Agenda Item: Authorize Change Order No. 3 with LaRiviere, Inc. for the Honeysuckle Avenue and Ramsey Road Roundabout Project for changes related to tree and stump removal, electrical service installation for the center island, and the addition of contract days for a net contract cost increase of \$13,723.10 and three (3) contract days.

CONTRACT CHANGE ORDER NO. 3

PROJECT: 41014.14 - HONEYSUCKLE AVENUE AND RAMSEY ROAD
ROUNABOUT IMPROVEMENTS

SCALE:	
PROJECT NUMBER:	HAYF0000-0015
SHEET NO. 16

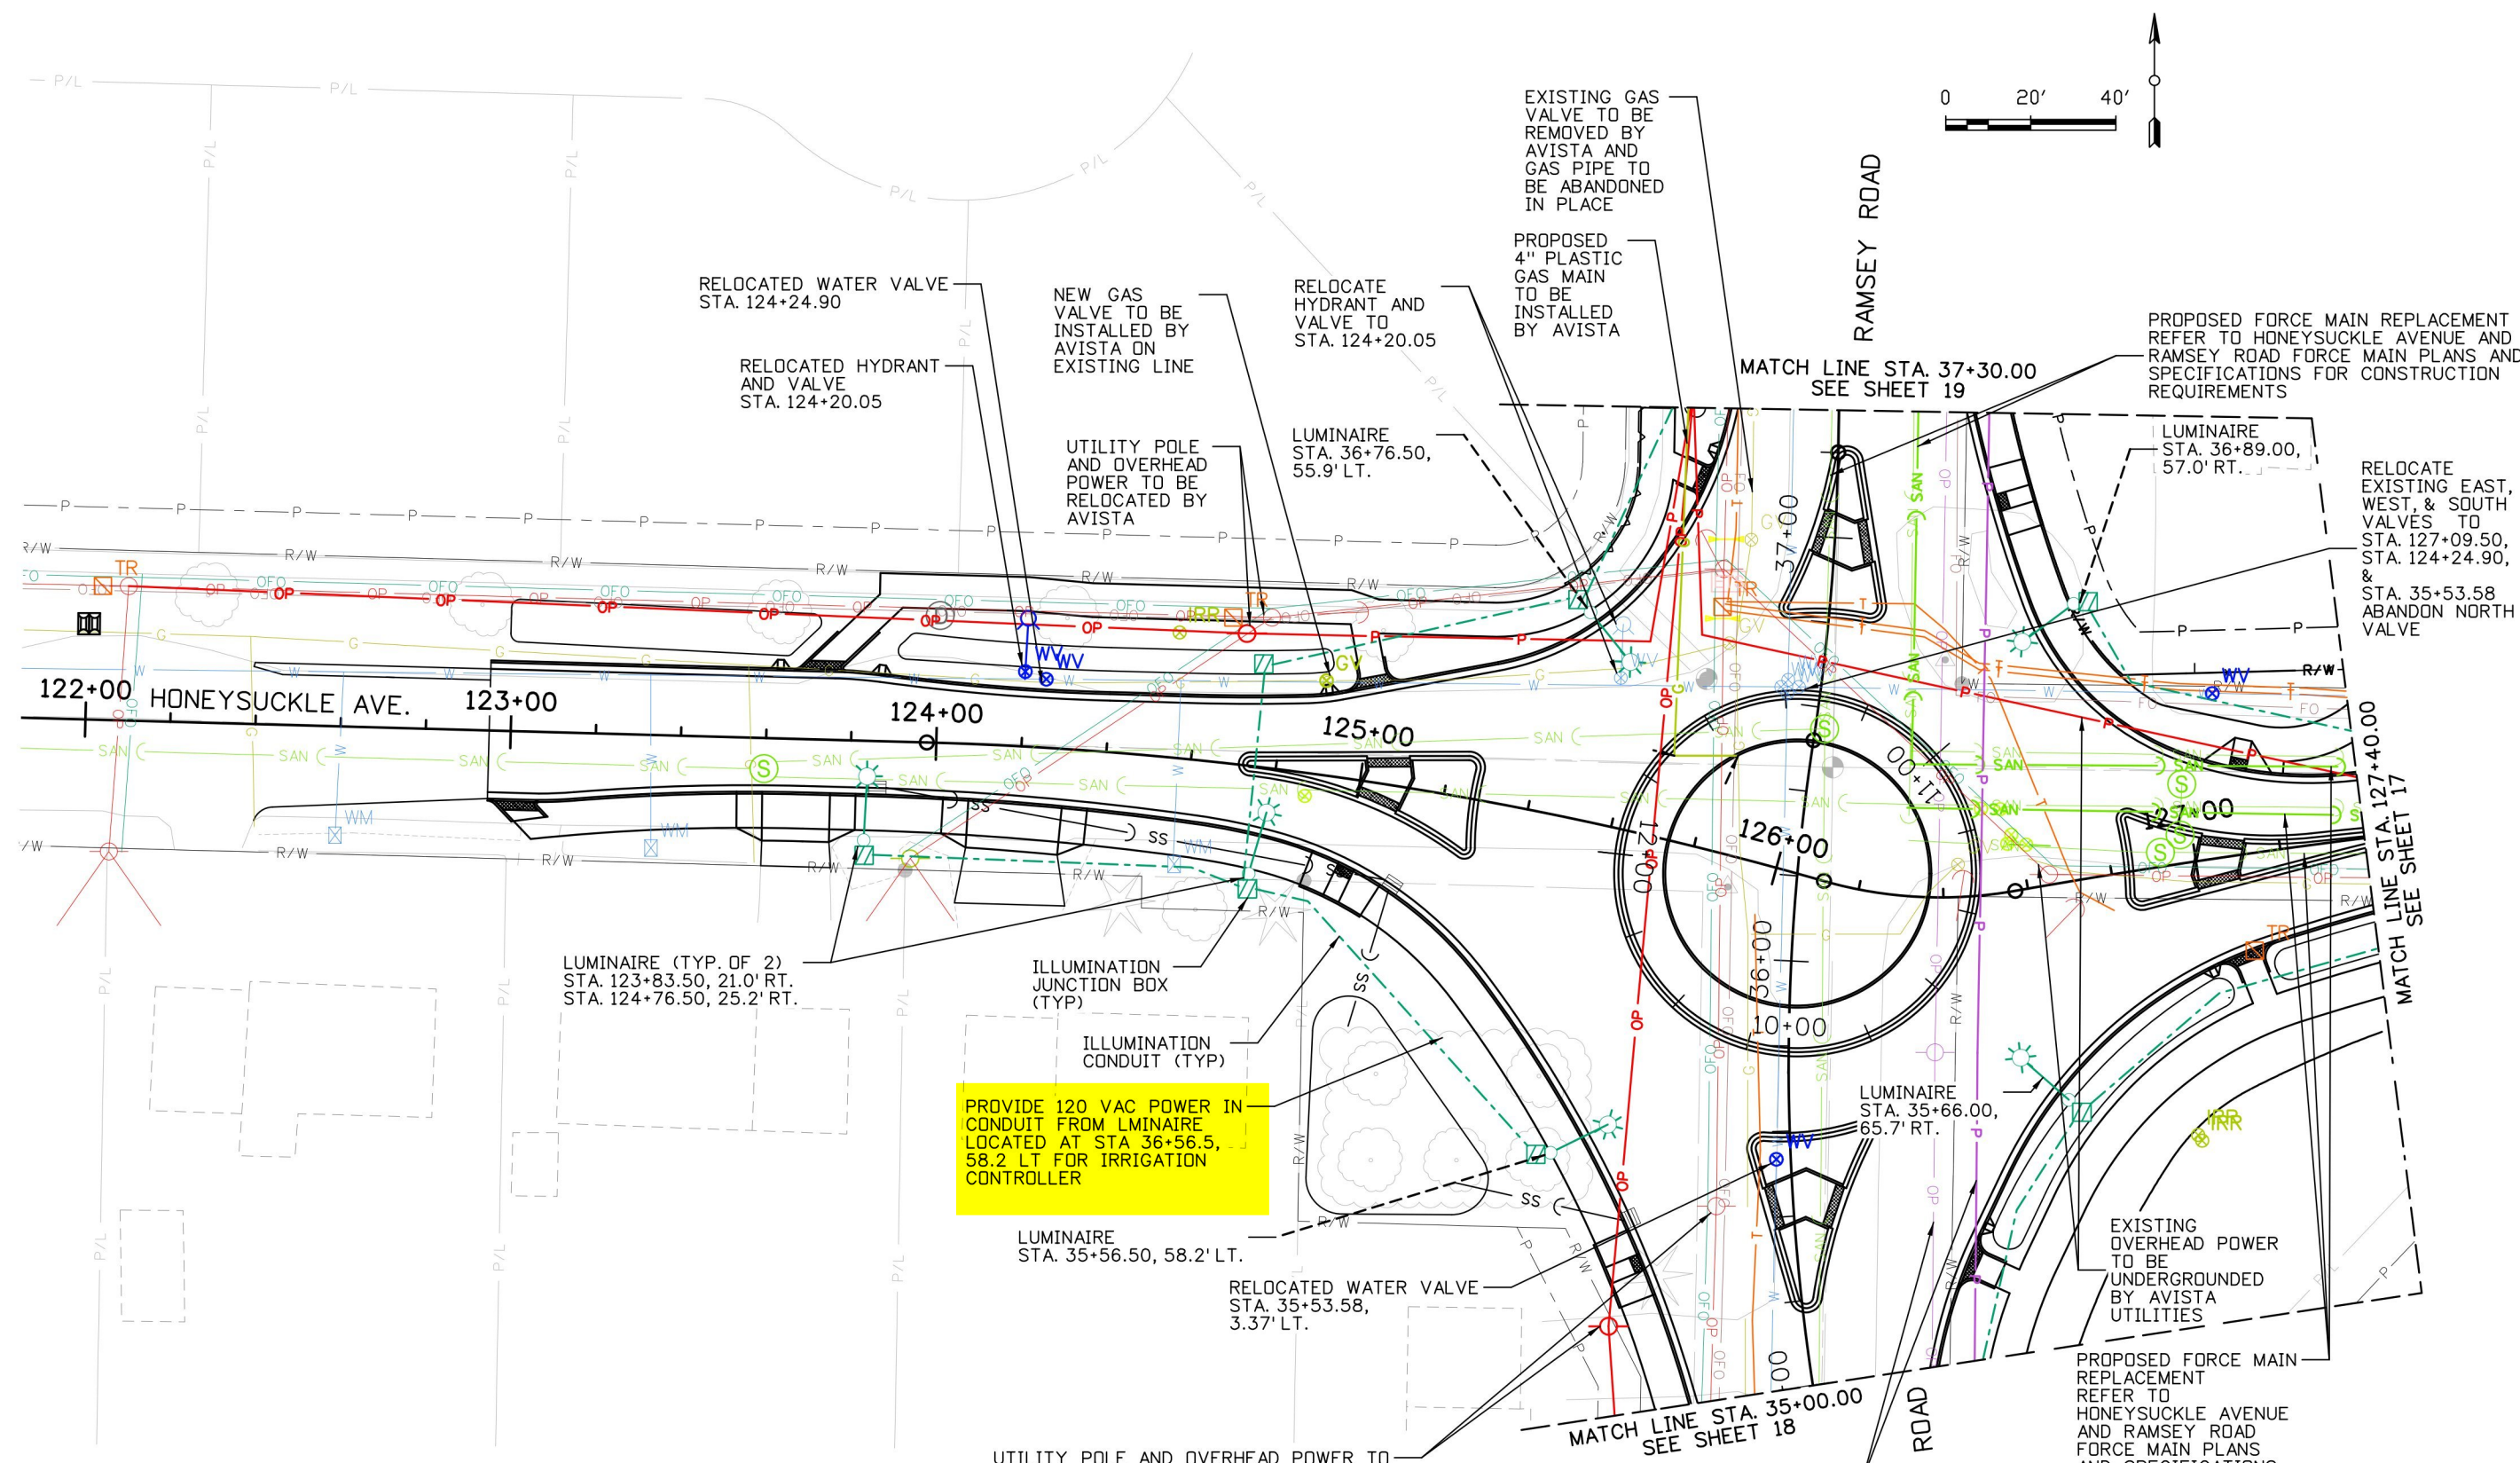
Sheet 16 indicates to provide 120 vac power in conduit from Luminaire for irrigation timer. There is no detail for this indicating whether it needs a separate panel, shutoff switch, etc... Prior to the bid I spoke with Thorco regarding this bid item and they stated there is not enough information/detail provided to bid this item. There is also a power source needed for the outdoor lighting transformer that does not appear to be addressed in the bid documents. Please advise on what is required and what will power the outdoor lighting transformer.

PROVIDE 120 VAC POWER IN CONDUIT FROM LUMAIRE LOCATED AT STA 36+56.5, 58.2 LT FOR IRRIGATION CONTROLLER

Provide Type 1 Service pedestal and associated components to allow connection of contractor designed and provided lighting system and irrigation system controls per response to RFI 13 and Contractor Change Request dated 8/26/26.

1. The plans and specs indicate that the landscape lighting is design-build. The contractor is responsible for the design and construction of a complete system to supply the lighting and irrigation as indicated on the plans. If the contractor thought they needed clarification during bidding to properly price this item, then they should have asked those questions during bidding. In the absence of other information, an appropriate standard of care would be what was completed at the 4th/Honeysuckle intersection (which Lariviere also constructed).

SHEET NO. 30

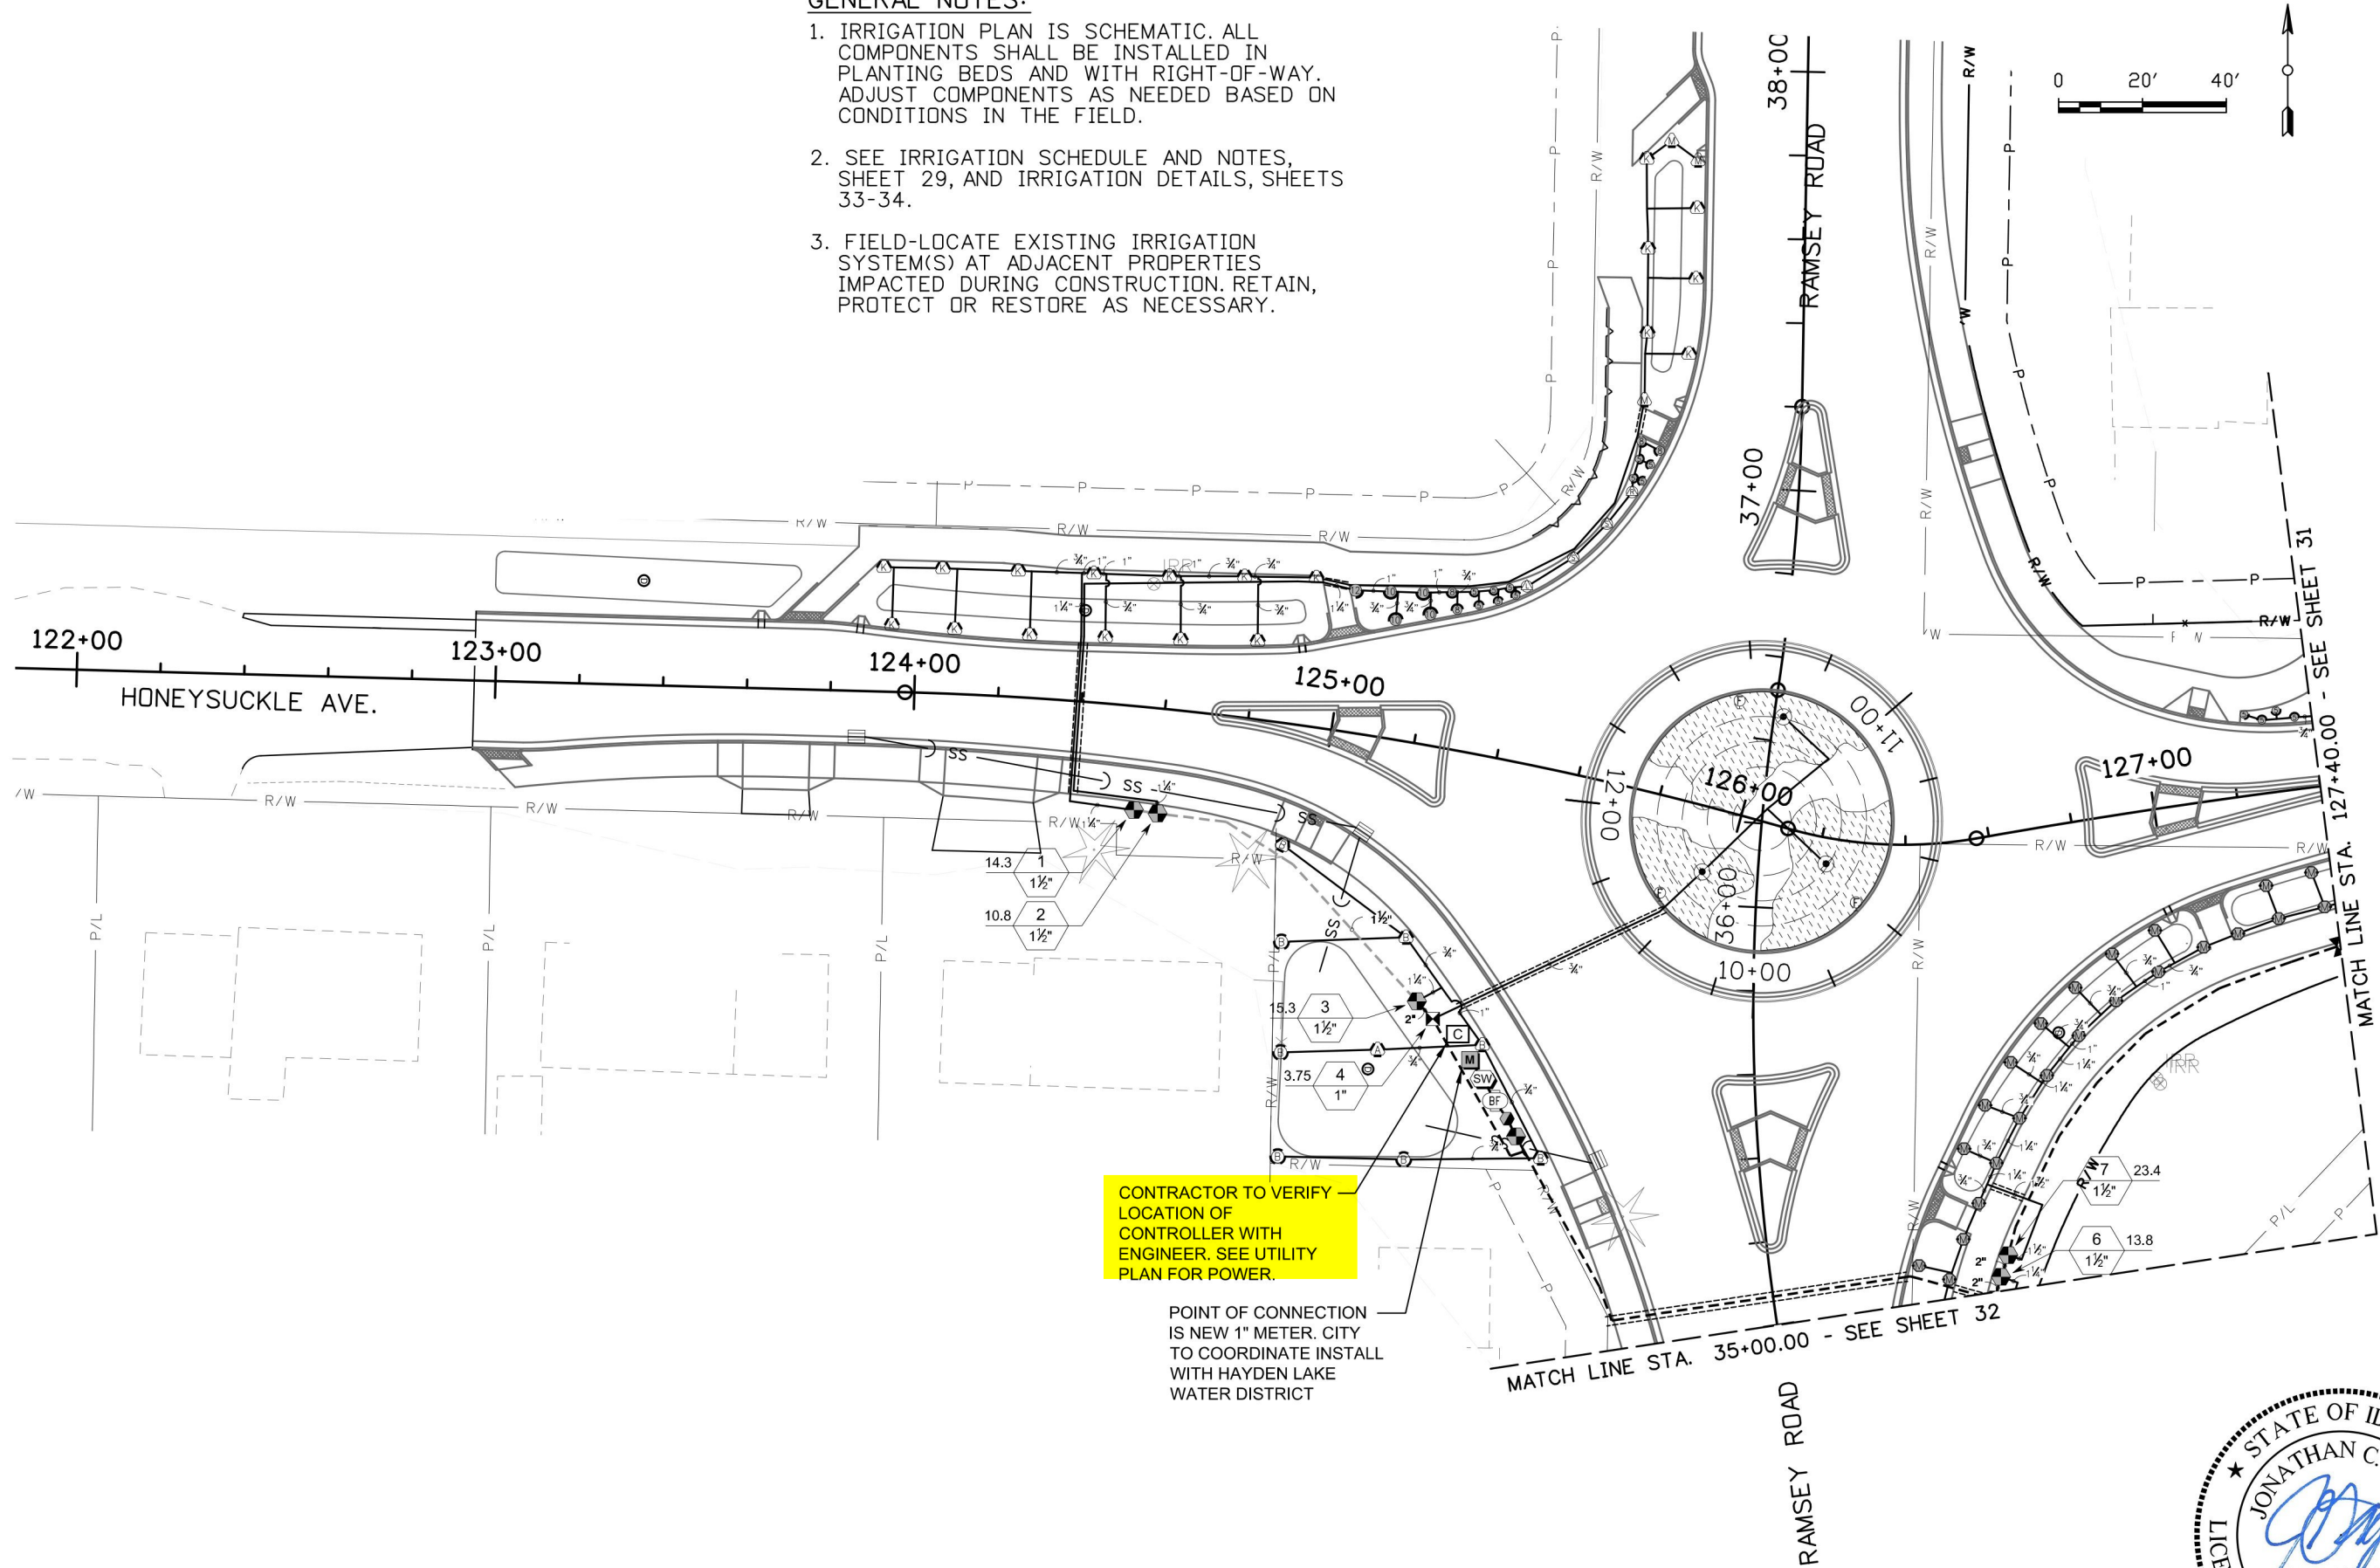
The irrigation prints do not appear to be included for the above area and no irrigation was bid for this area due the print not existing. Will this area require irrigation and if so will a plan be provided? The sprinkler layout could be done in the field and reviewed without a print if this area is to receive irrigation.

2. Irrigation from Station 38+00 to 41+25 is planned to be retained and protected or restored if impacted, identified by the irrigation General Note 3 on the irrigation plan sheets.
